TRANS/WP.29/GRSG/2001/1
12 January 2001

World Forum for the Harmonization of Vehicle Regulations (WP.29)

PROPOSAL FOR DRAFT AMENDMENTS TO REGULATION No. 52
(Small capacity passenger vehicles)

Transmitted by the Expert from Poland

Annex 3, Figure 1, amend as following:

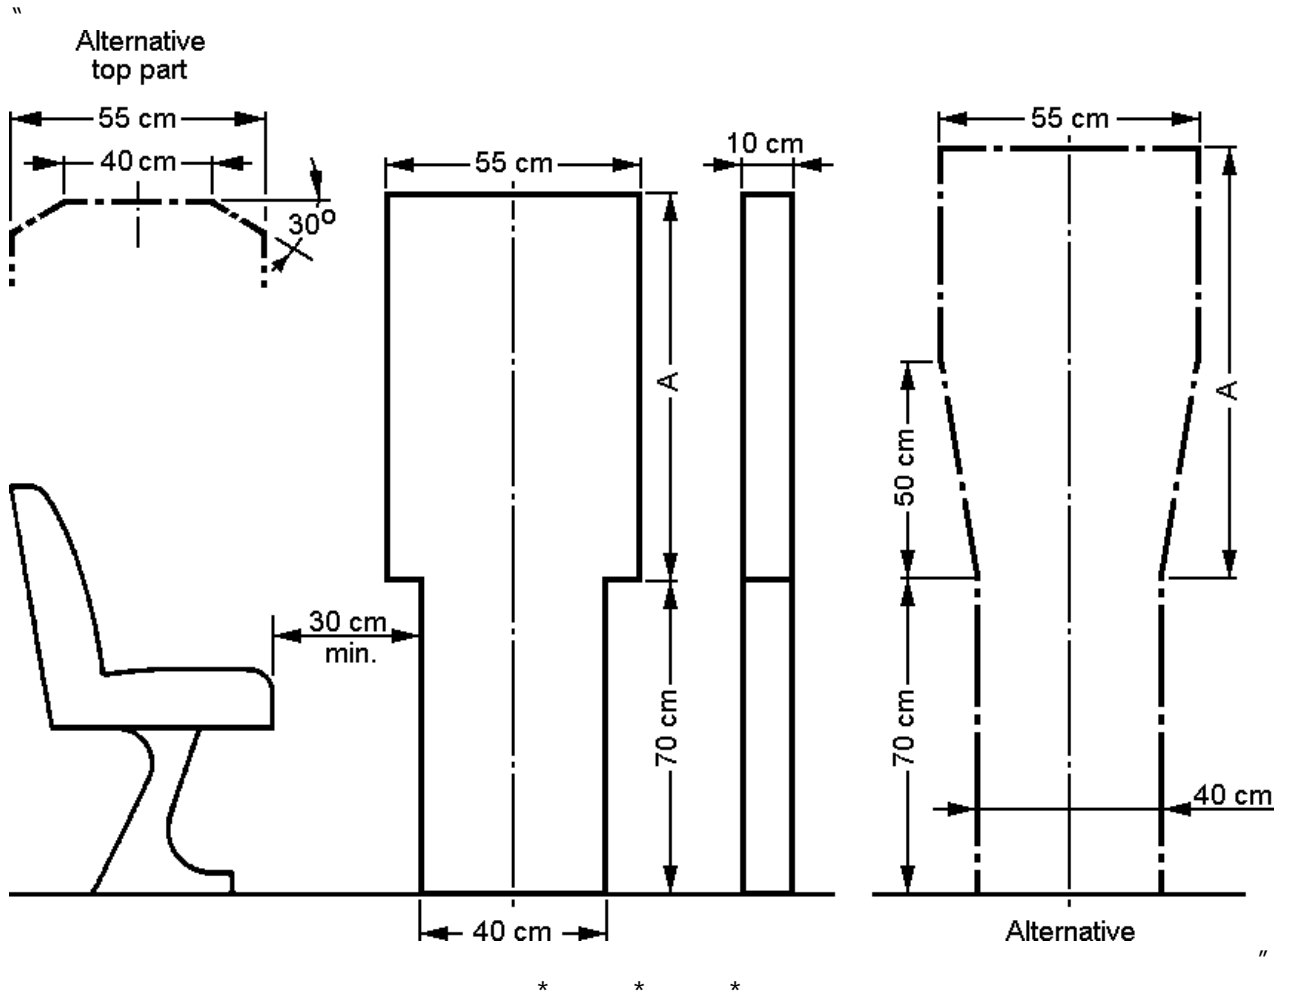
The "alternative top part" which is described in the third subparagraph of paragraph 5.7.1.1. was not shown in figure 1 of annex 3, as referred to.
